SPRUCE RUN DAM

PHASE I INSPECTION REPORT
NATIONAL DAM SAFETY PROGRAM

NJ 00132

DEPARTMENT OF THE ARMY
PHILADELPHIA DISTRICT, CORPS OF ENGINEERS
CUSTOM HOUSE - 2D & CHESTNUT STREETS
PHILADELPHIA, PENNSYLVANIA 19106
25 APRIL 1978

PHOTOGRAPHIC DESCRIPTION SHEET

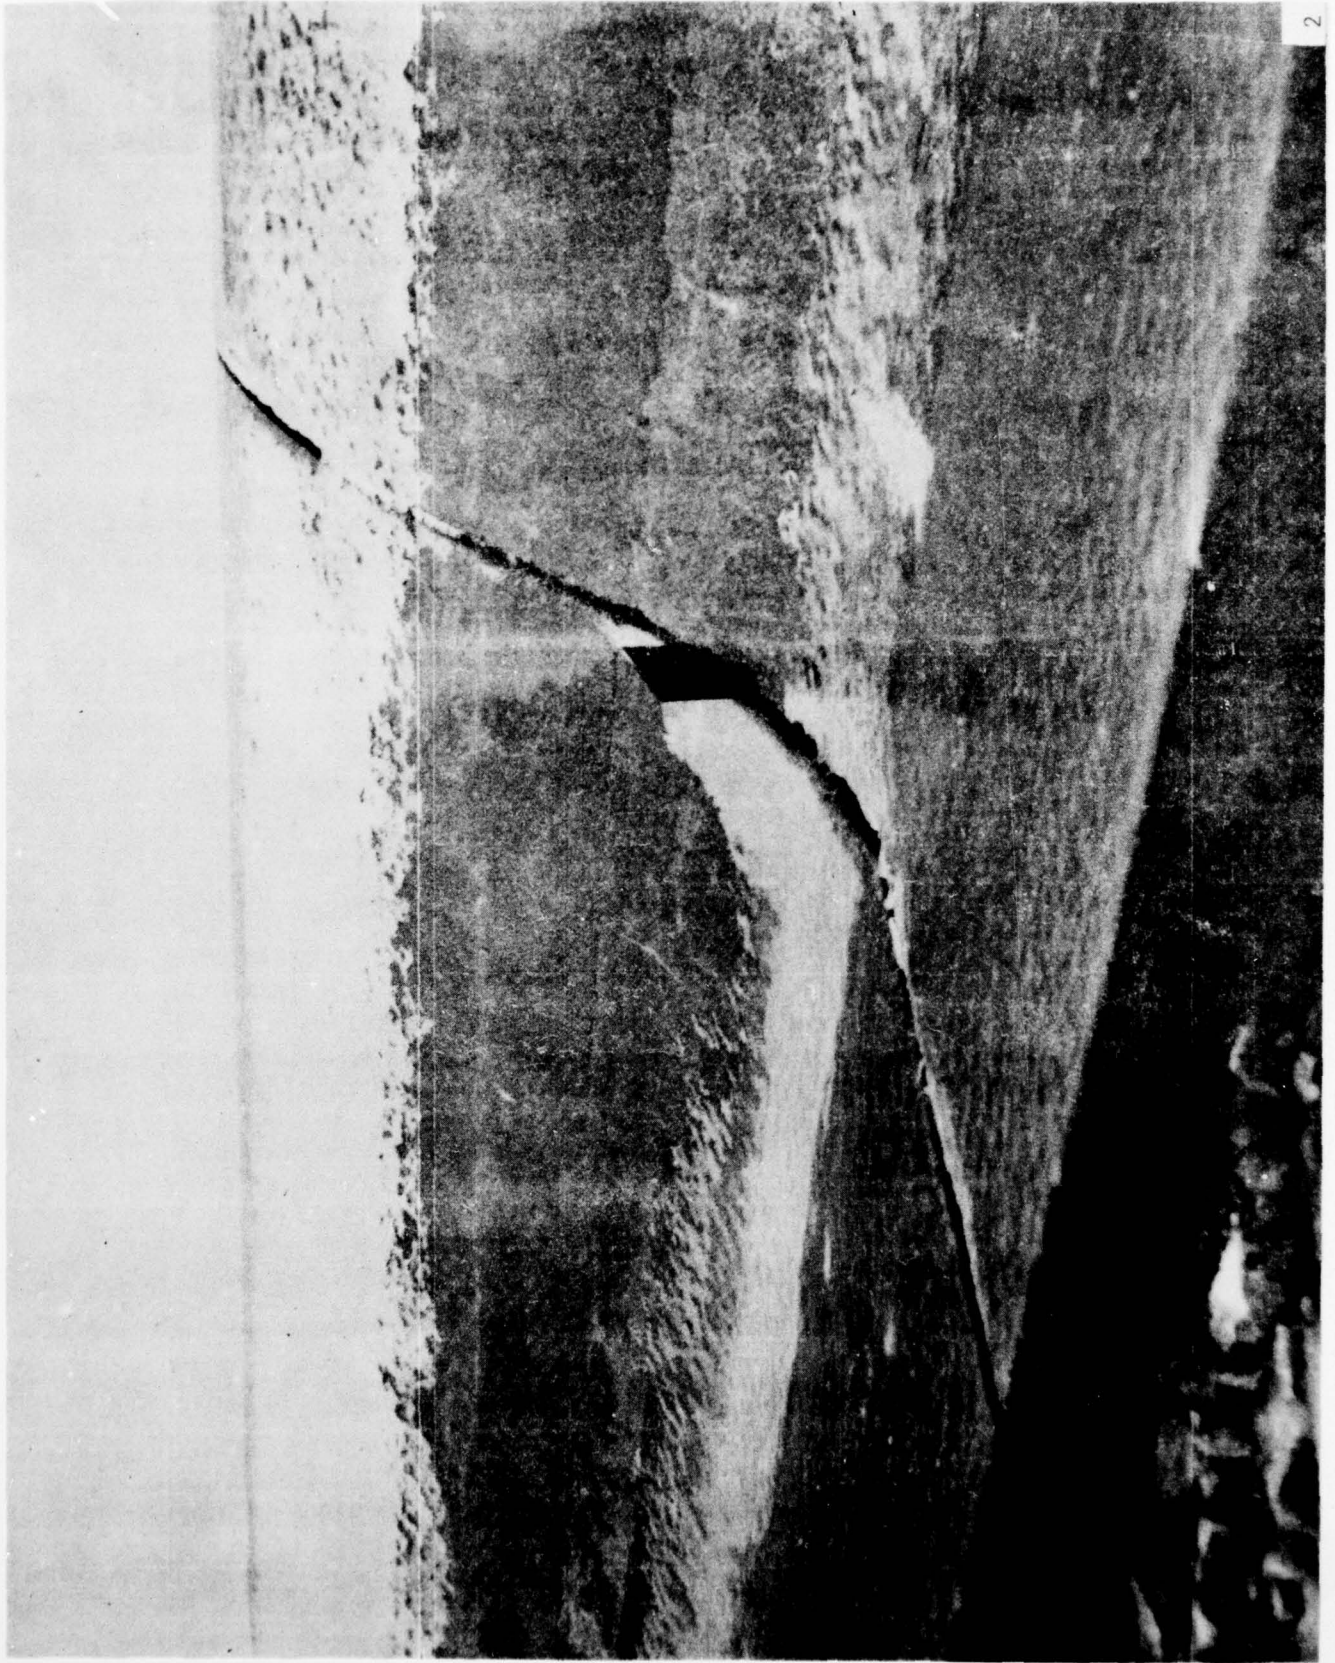
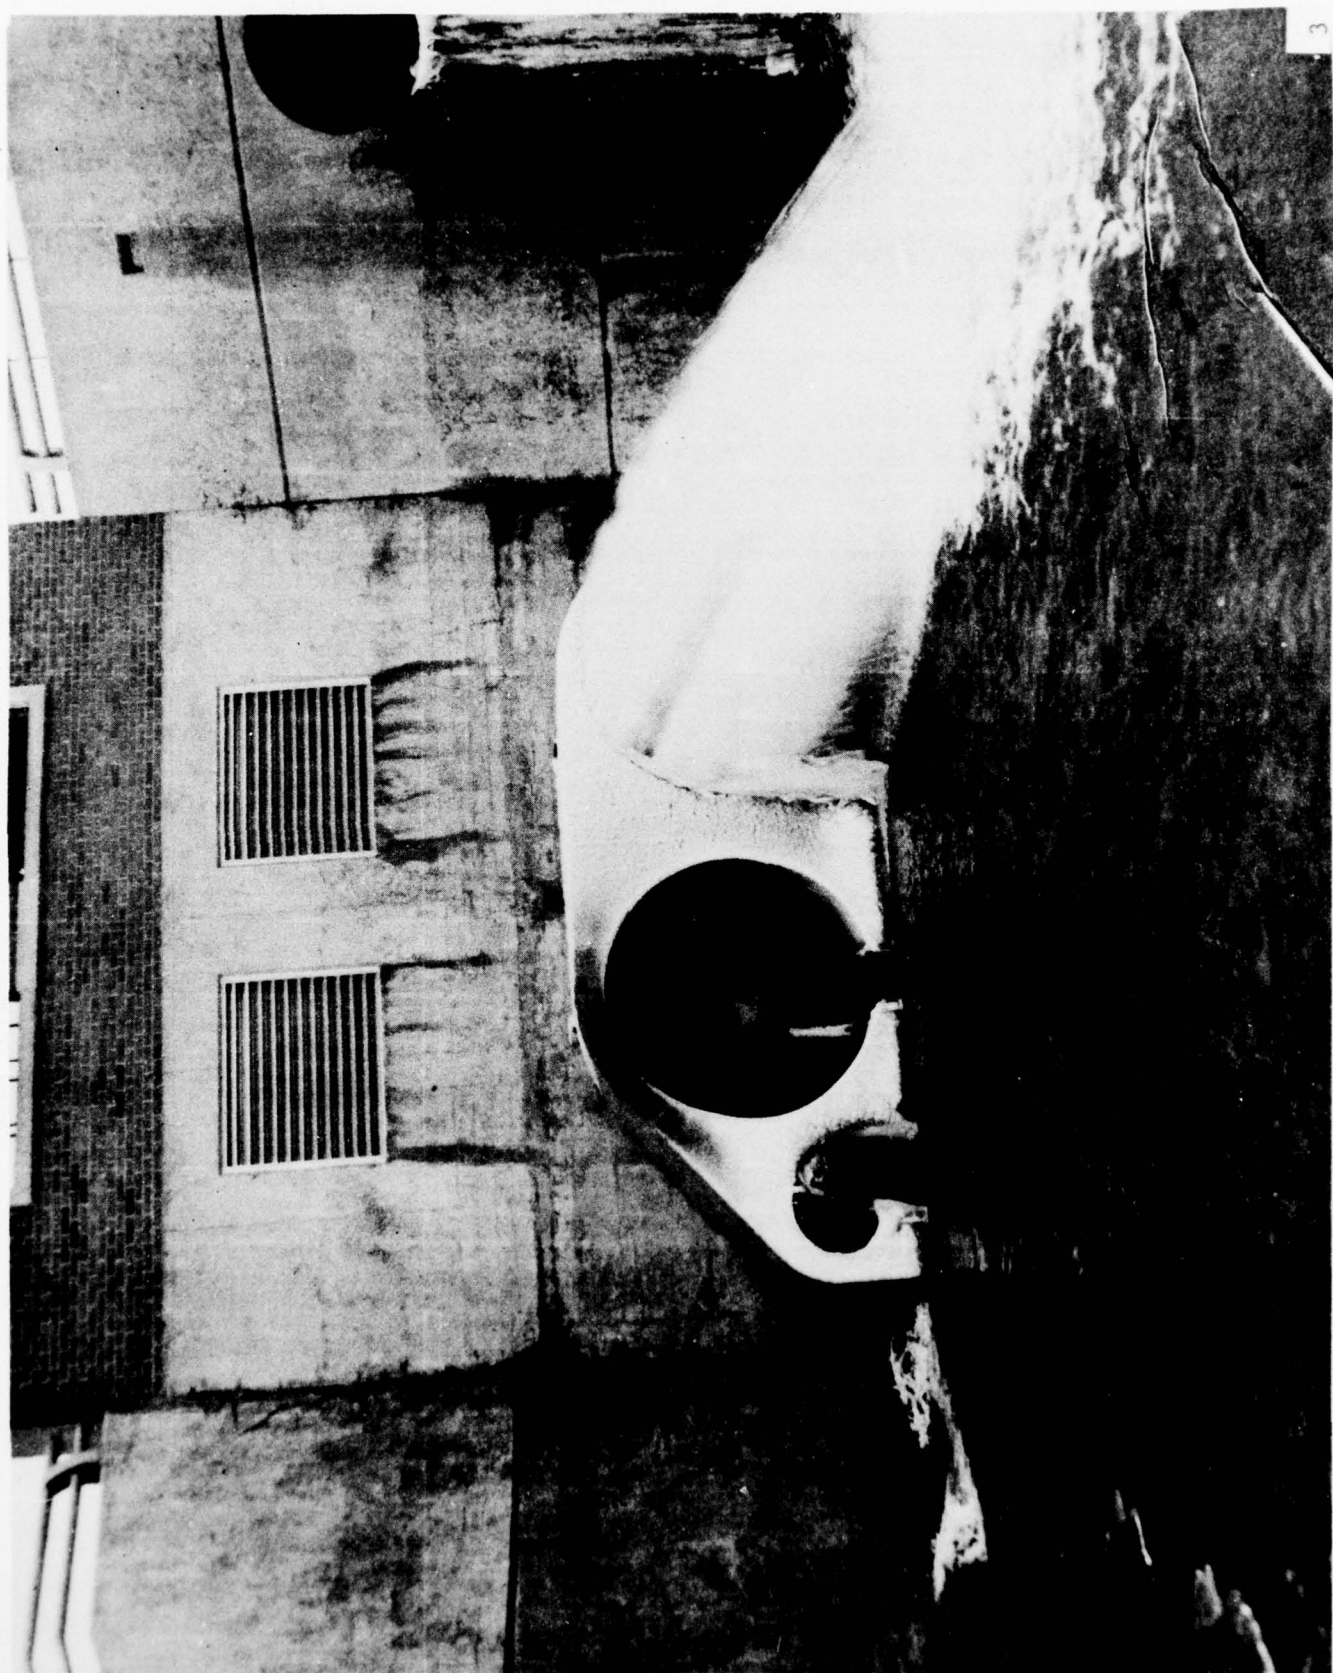
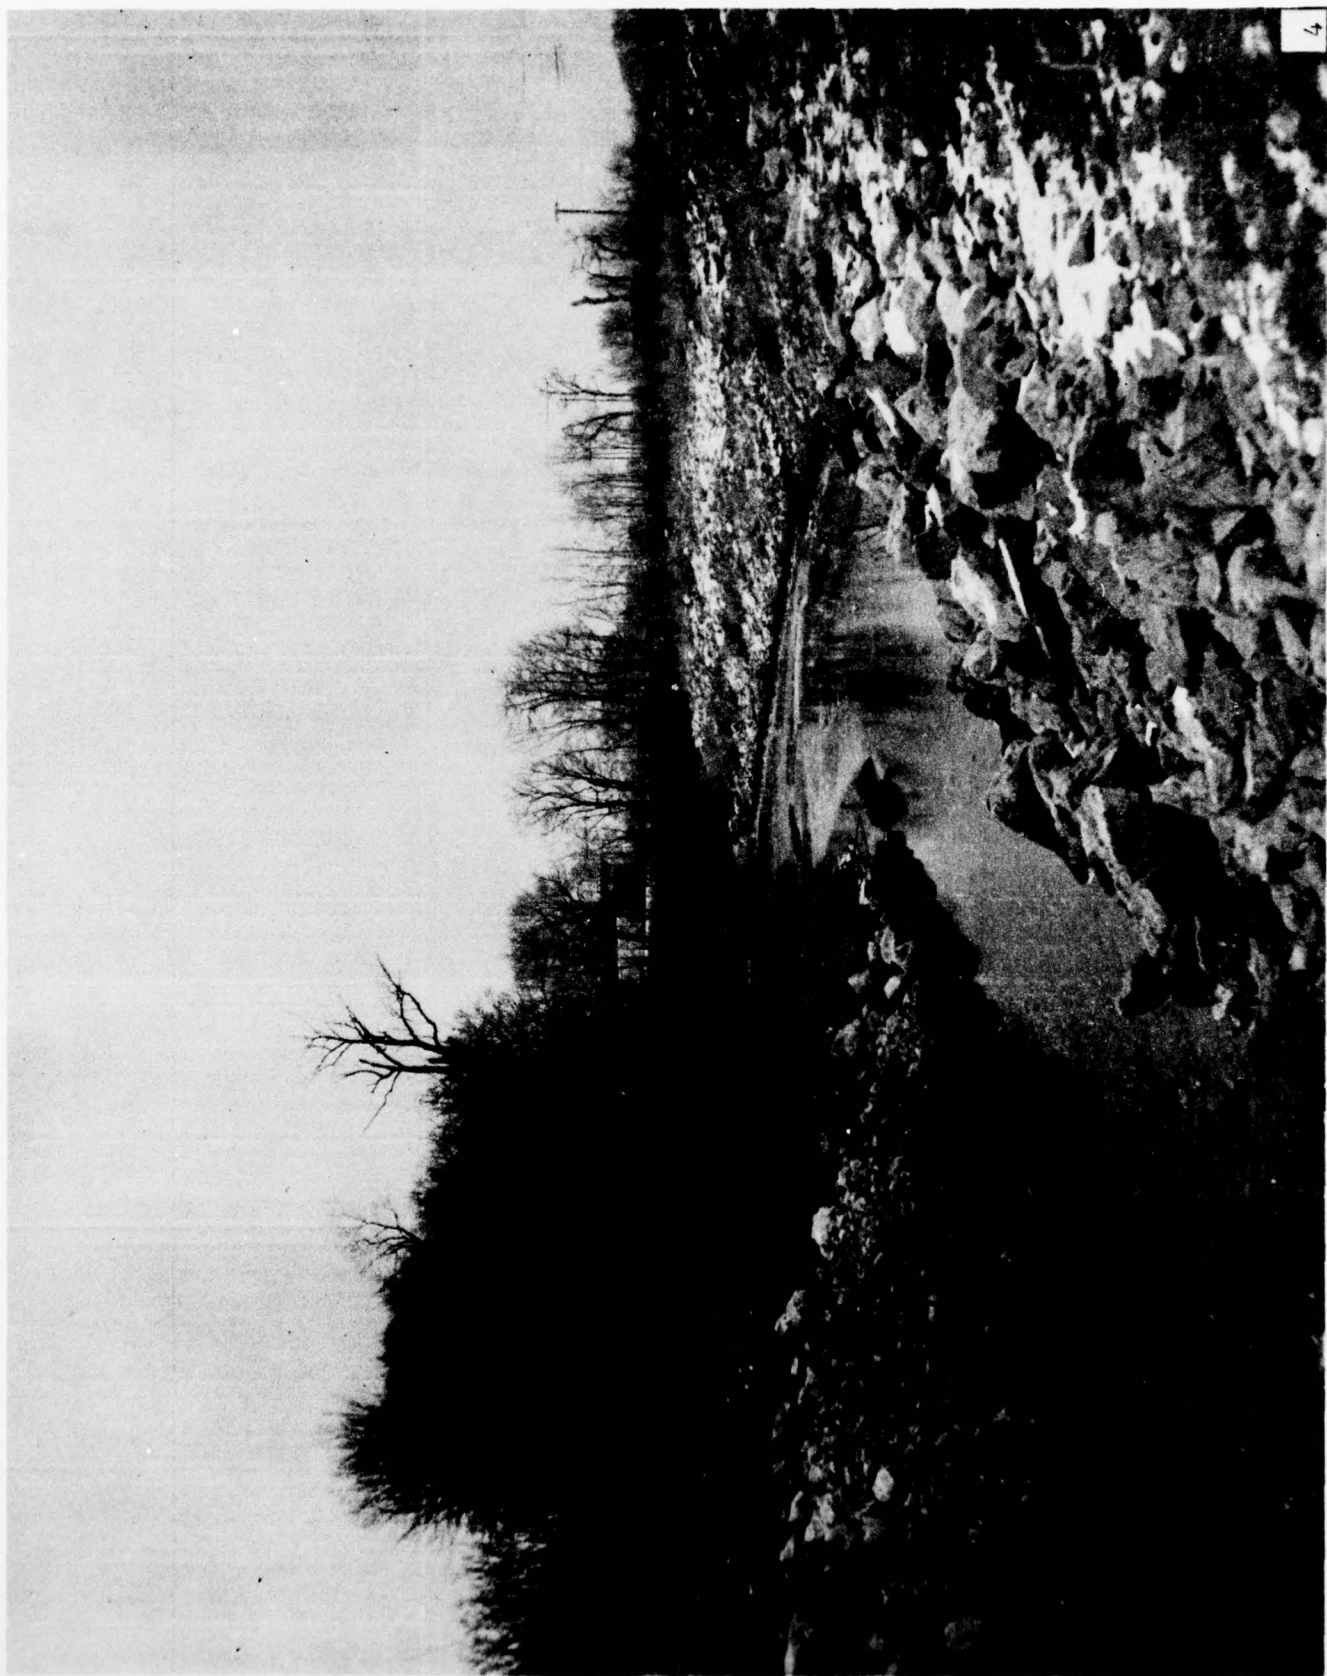
View of typical joint of concrete ogee weir indicating open joint and loss of joint filler.

View of two 30" venturi outlets with conical regulating devices, one of which is operational.
